**Our Case Number:** ABP-316828-23

**Re:** Tallaght/Clondalkin to City Centre BusConnect Core Bus Corridor Scheme.  
Tallaght/Clondalkin to Dublin City.

## **Tallaght/Clondalkin to City Centre BusConnect Core Bus Corridor Scheme.**

**Case/Reference number: 316828**

Picture 1

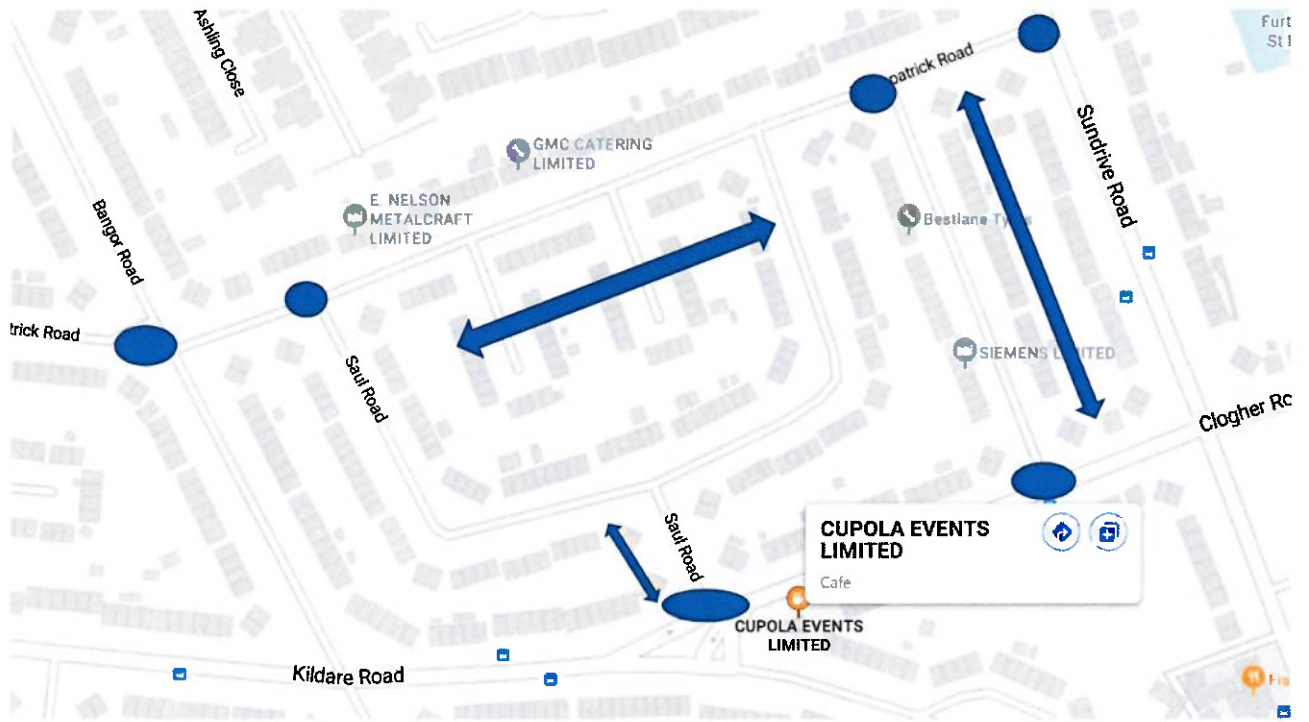
Highlighted below (picture No1) is the proposed plan for Saul Rd/Kildare Rd junction, my concern is traffic using Kildare Rd will use this junction as a "short cut" to Crumlin Rd/Sundrive Rd junction at Sundrive Rd Garda Station through Saul Rd on to Downpatrick Rd causing increase traffic flow on to Saul Rd during peak hours (AM & PM). This will have a considerable effect on the residents of Saul Rd and surrounding roads such as

1. causing delays for residents of Saul Rd who are either leaving for work or dropping children to school
2. increase fumes from idling cars
3. cause a delay/obstruction for emergency services to gain access to Saul Rd and surrounding roads if needed
4. increase the use of Saul Rd as a cut through for taxis, delivery drivers, food delivery etc. and general use by the public because of restricted access at the end of Clogher Rd and Sundrive Rd during peak and off-peak hours
5. As Saul Rd and Downpatrick Rd are designated residential areas, they are not designed for the increased volume of traffic which is already seen because of the cycle lane on the junction Clogher Rd/Sundrive Rd at St Bernadettes Church. Traffic is using Slane Rd/Saul Rd as a cut through and because of the lack of speed ramps on either road there is a danger to all residents especially children who play outside.

**Sec 1 a.** It is also uncertain if the Saul Rd/Clogher Rd junction is to be "one way" and if Downpatrick Rd is also to be a one-way road. If so the only entrance to my home would be at the Bangor Rd/Downpatrick Rd junction. As of the present time there are three points i can either enter or exit my residence. This will give me and the residents of Saul Rd and surrounding roads the feeling of been enclosed and cut off from not just the greater Crumlin area but to the city center and other important amenities such as shopping and health care. The impact of such proposals will have a direct impact on the community which An Bord Pleanala may not realize. (picture No2)

Picture 3

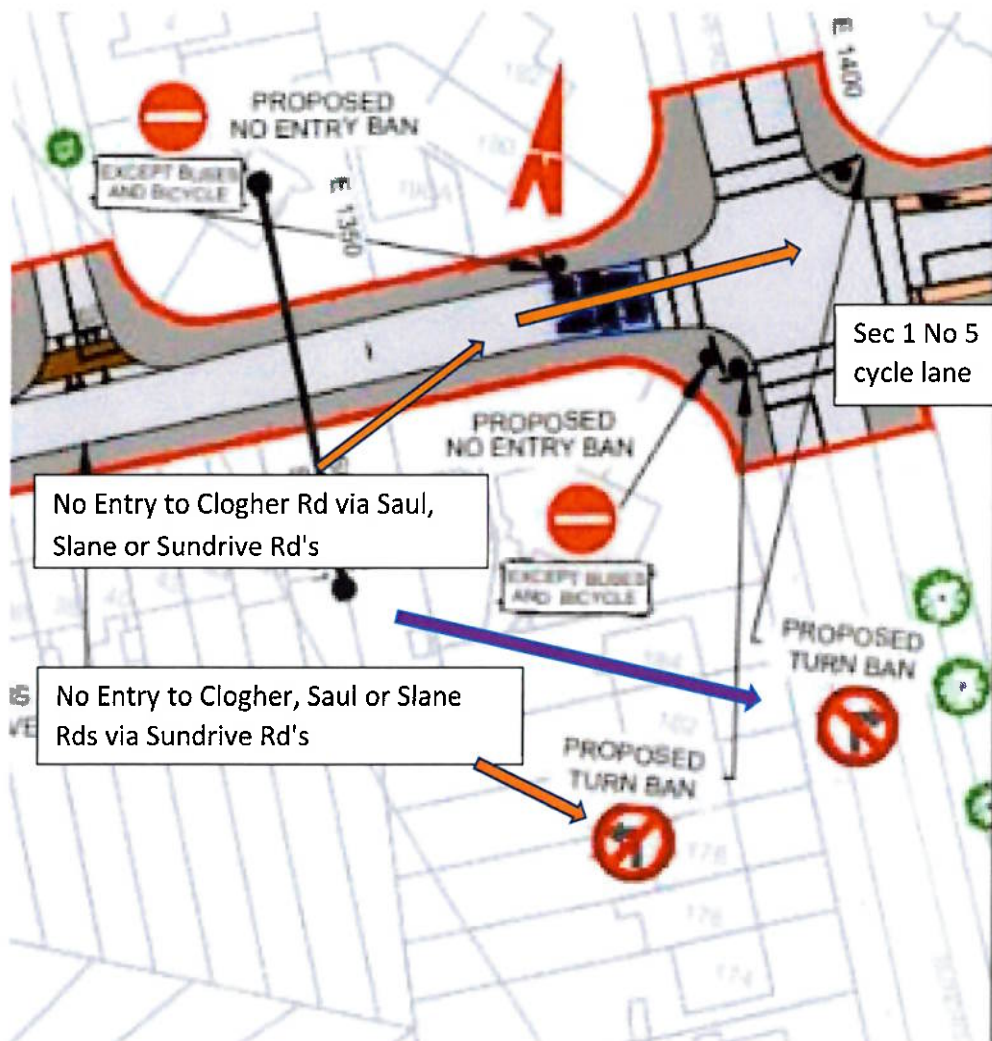
As proposed, the Clogher Rd closure & 'No right turn' at the Clogher Rd/Sundrive Rd Junction at St Bernadette's Church (picture 3) denies me, the residents of Saul Rd and the greater Crumlin area vehicular access to the city center through Clogher Rd via the Junction at Clogher Rd/ Sundrive Rd, Sallys Bridge and the South Circular Rd. Furthermore, because of the proposed closure of Clogher Rd.

**Picture 4**

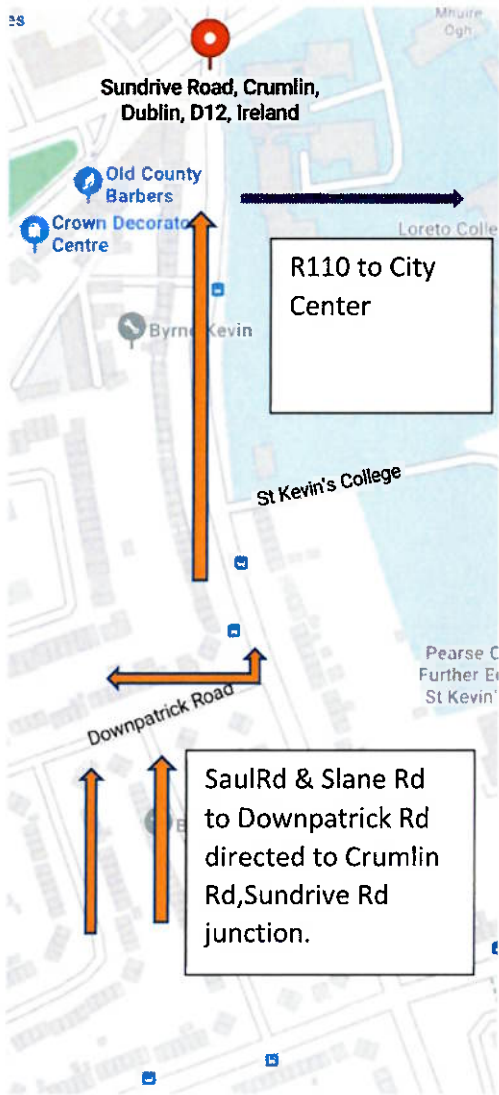
It forces me and the above mentioned to either be diverted through the Sundrive Rd/Crumlin Rd junction (which will have a high volume of traffic due to proposed corridor through Crumlin Rd picture 4) or the junction of Sundrive Rd/Larkfield Park which again will have a high volume of traffic due to proposed corridor (picture 5). This is totally

Proposed change at Clogher Rd/Sundrive Rd junction forcing route through Crumlin Rd/Sundrive Rd junction to city center via R110

**Picture 5**

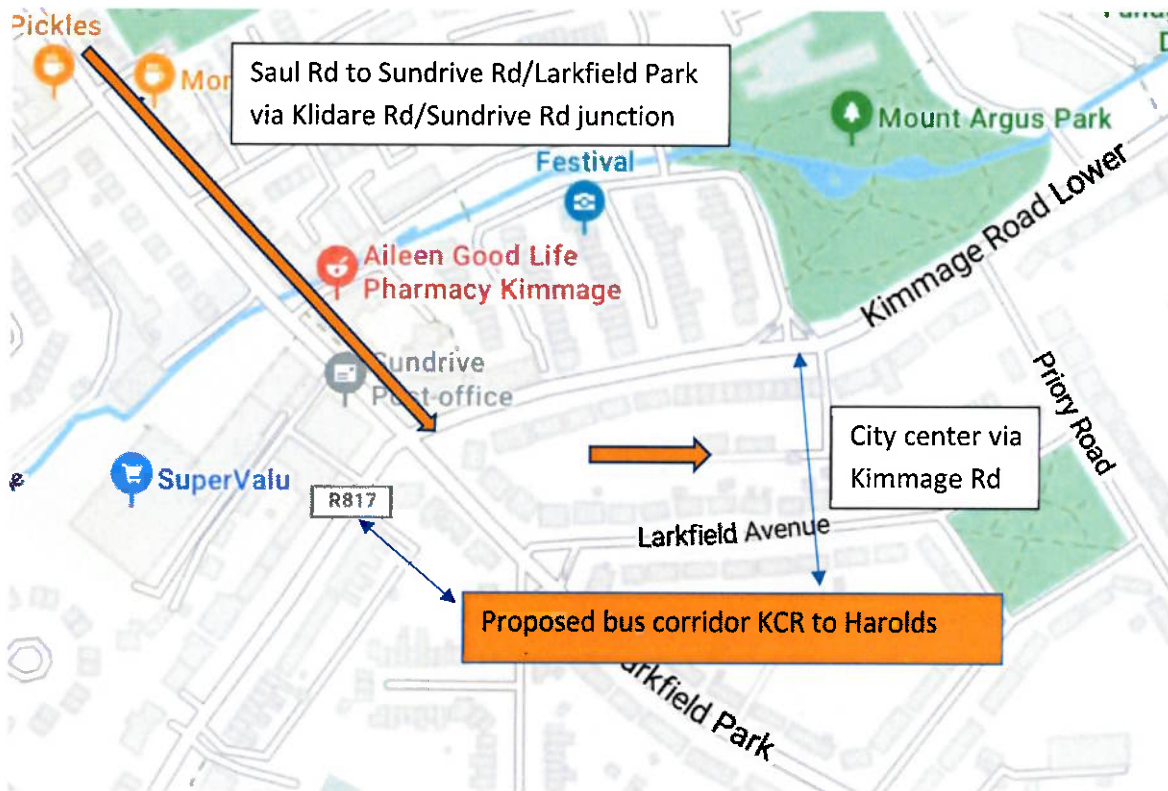
Proposed change at Clogher Rd/Sundrive Rd junction forcing route through Sundrive Rd/Larkfield Park junction to city center via Kimmage Rd lower
